REVIEW OF PRELIMINARY PLAN - by
Foundations Office.

Re: Bridge No. 6, Southwold Twp.,
Hwy. 401, Lots 1 & 18, Con. III,
W.P. 63-59 -- District 2.

RE: W.P. 63-59,
Southwold Twp. Br. #6,
Proposed Underpass @ County Rd. To Southwold Junction,
C.A.H. 401, District #2.

PRELIMINARY PLAN

SOUTHWOLD TWP.
BRIDGE N° 6

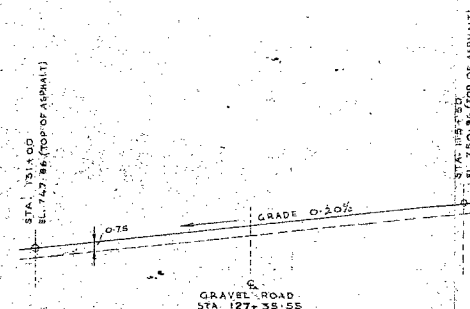
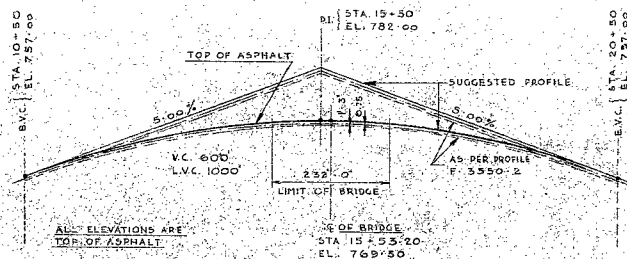
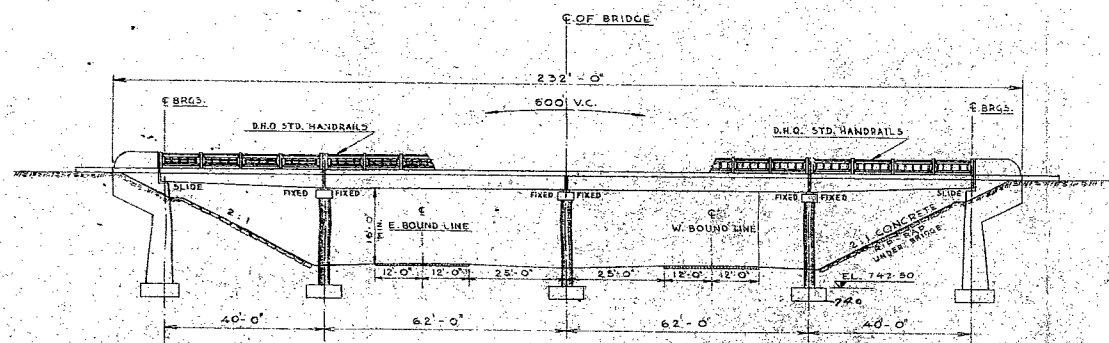
We have reviewed the preliminary plan for the above-noted structure. We understand that the bridge is a simply-supported, multi-span structure and, therefore, will be able to take care of differential settlements which are going to take place. The fact that the footings are placed two feet above the elevation proposed in the Soils Report, does not influence the bearing capacity value of 2 tons/ft.² and the design is therefore considered to be satisfactory.

Can footings be
at elev. 740.0
Report says at 738.0
